Falcon Highlands

Final Drainage Report

Provide PCD file No.
SF2418

June 10, 2024

DETENTION BASIN STAGE-STORAGE TABLE BUILDER

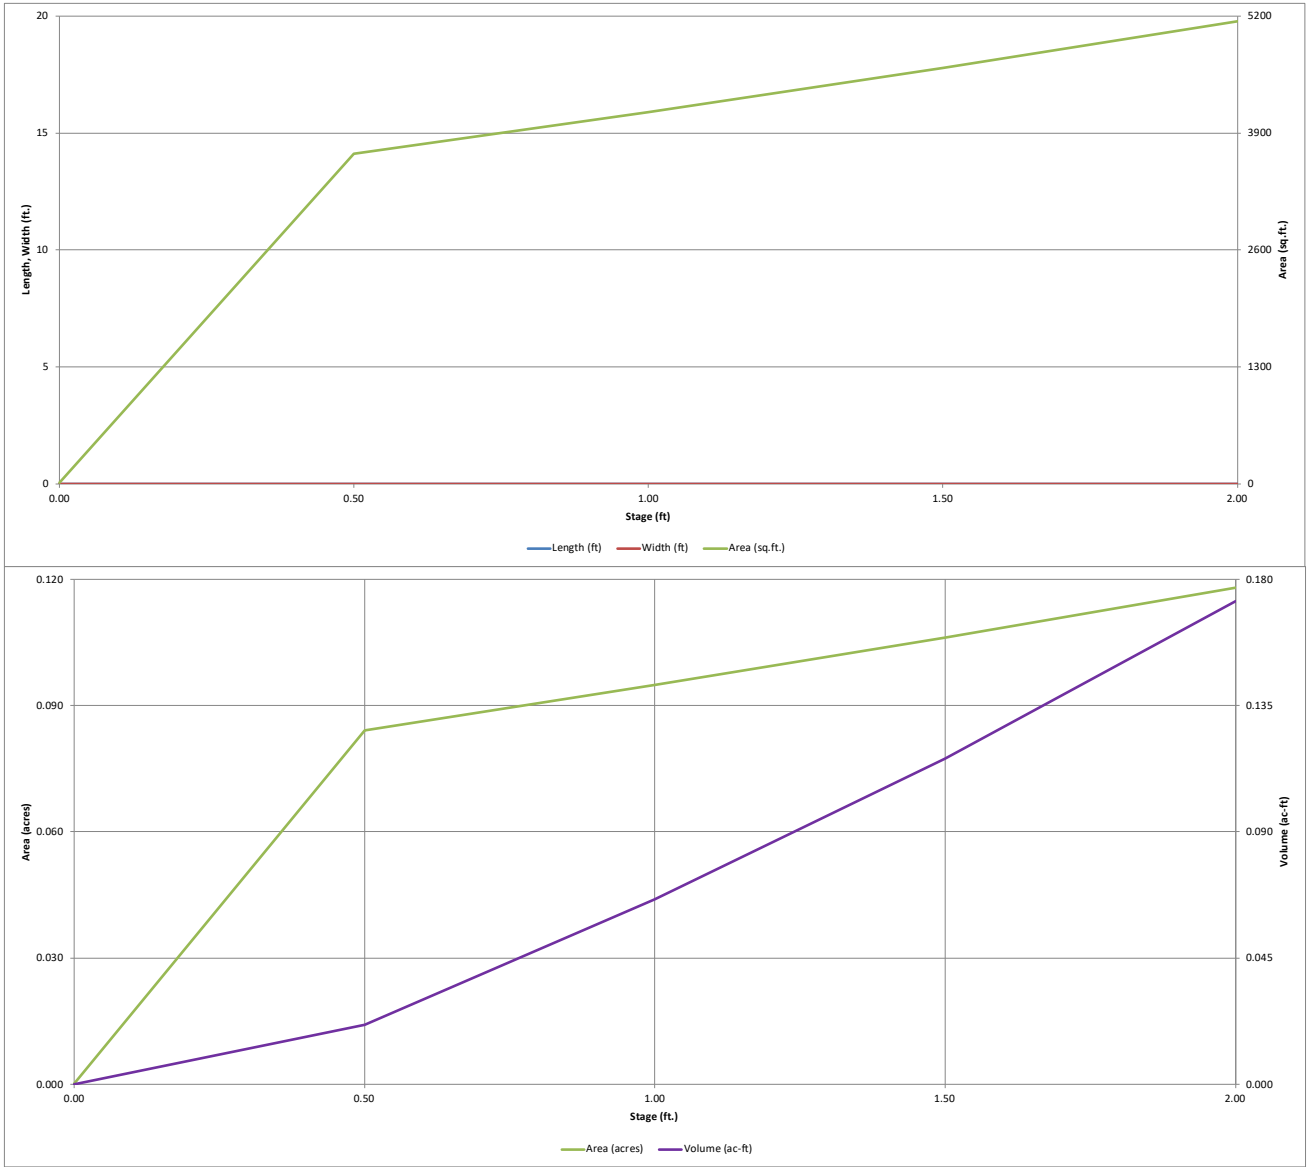
Move these calculations to the hydrology section of the appendix

Trapezoidal

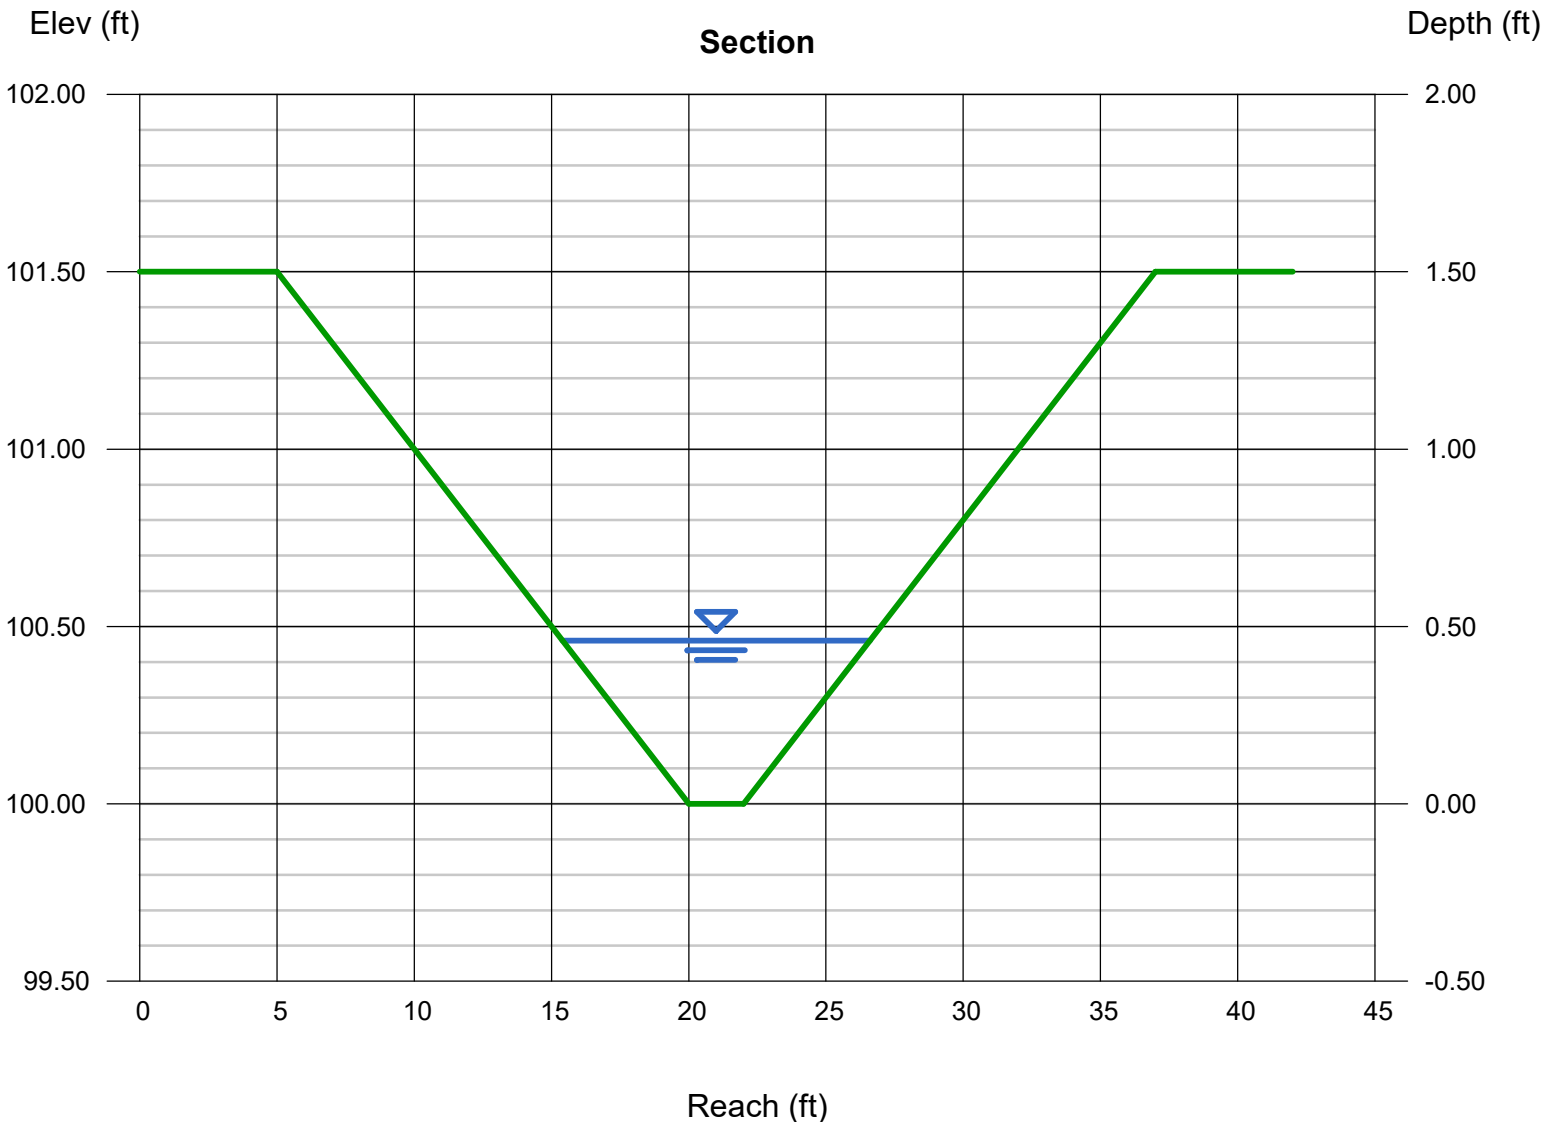
Provide name for ditch so it is clear where this analysis applies and what storm the analysis is for.

Trapezoidal

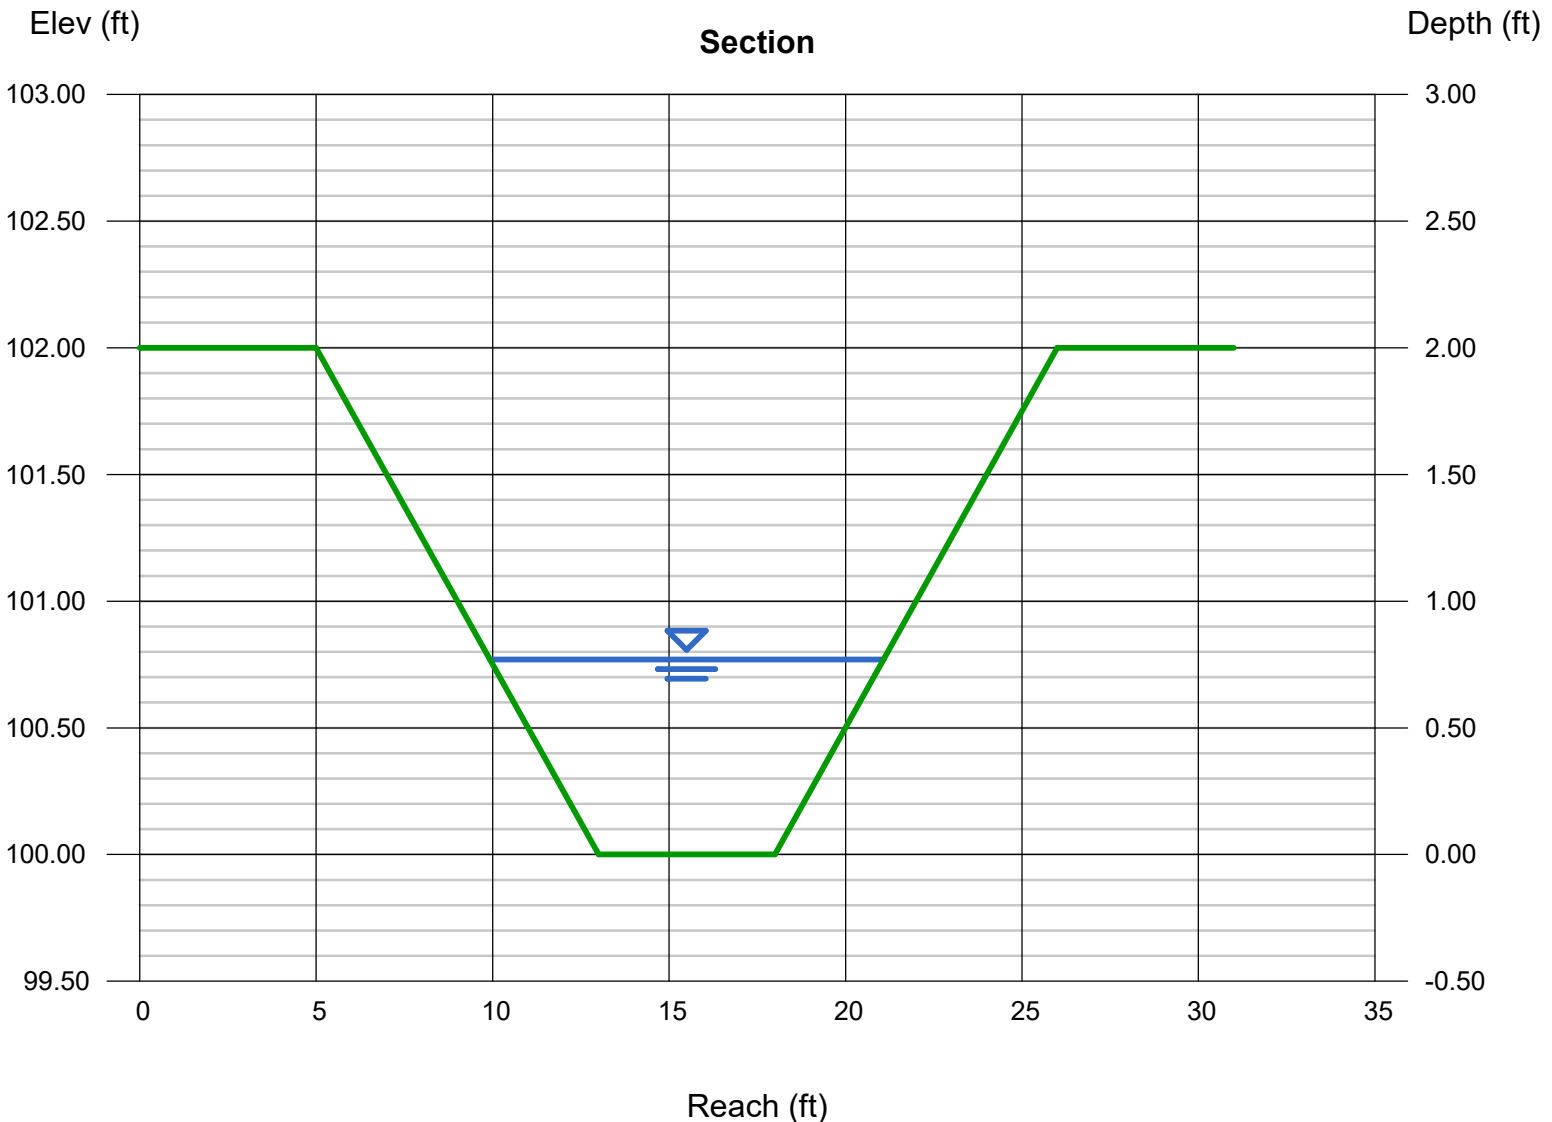
Provide name for ditch so it is clear where this analysis applies and what storm the analysis is for.

CHALLENGER HOMES
FALCON HIGHLANDS SOUTH - FILING 1
EL PASO COUNTY, COLORADO
DRAINAGE MAPS
EXISTING DRAINAGE MAP

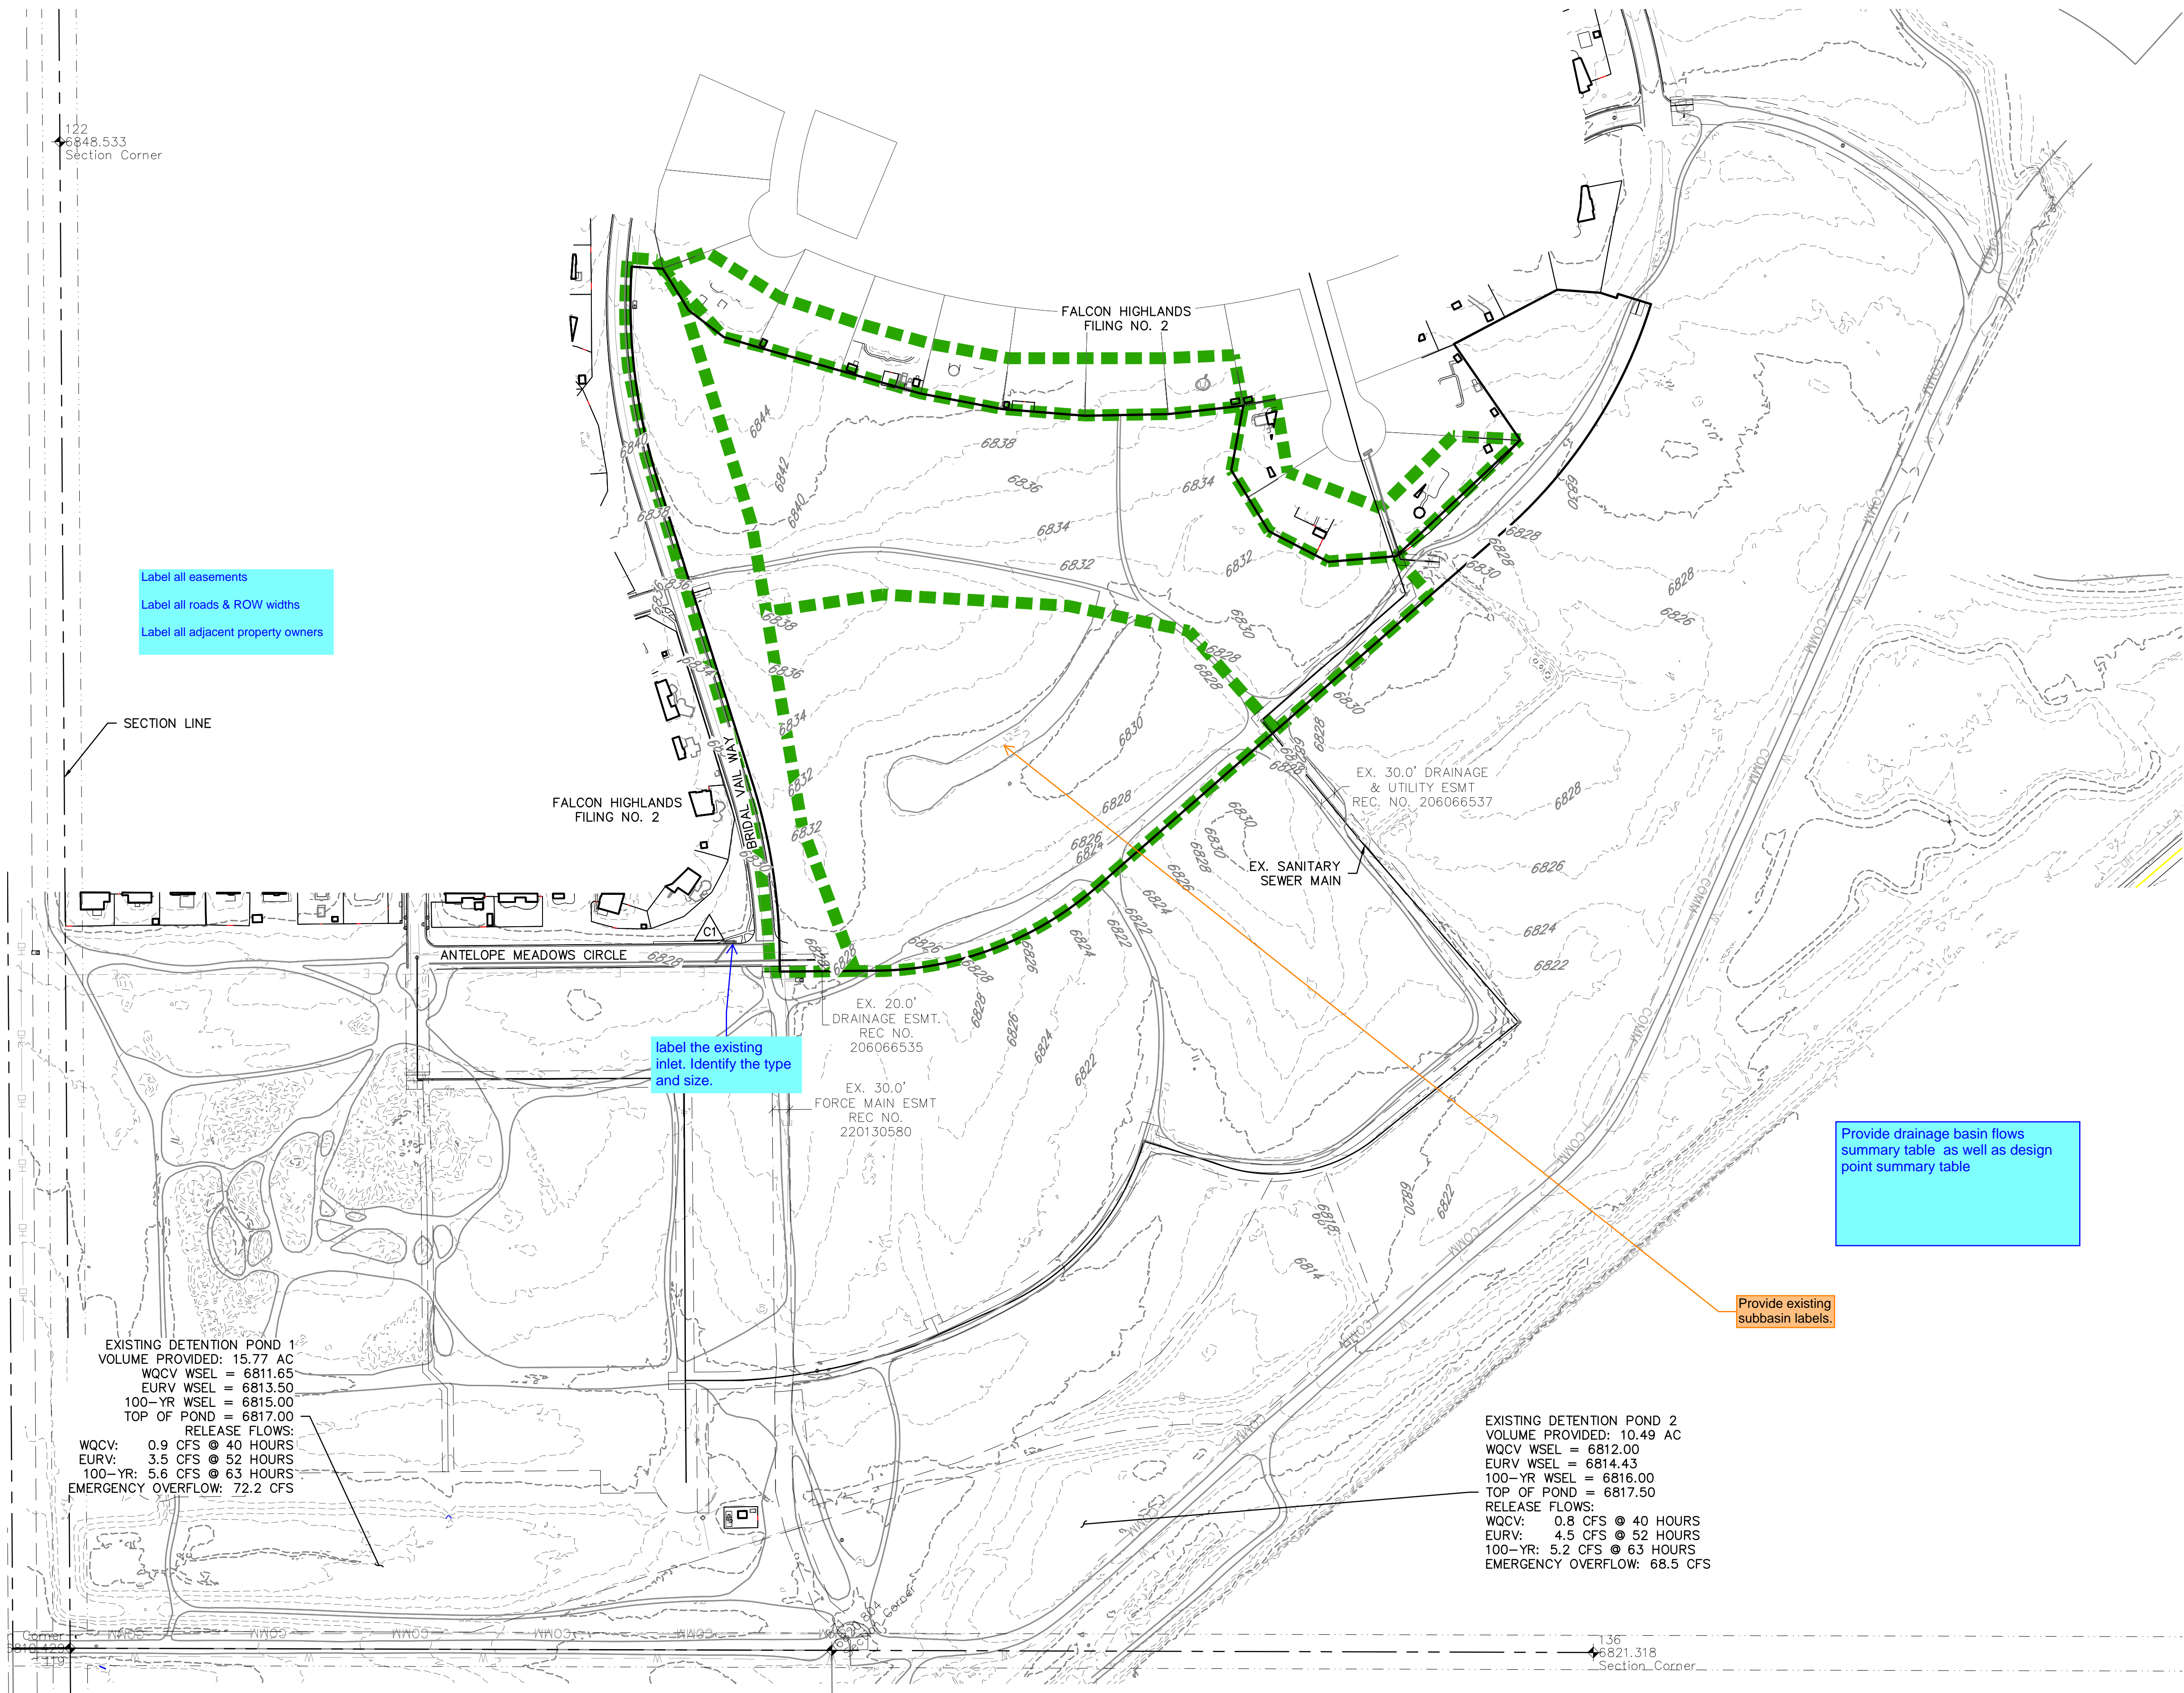
Provide drainage basin flows summary table as well as design point summary table

Provide existing subbasin labels.
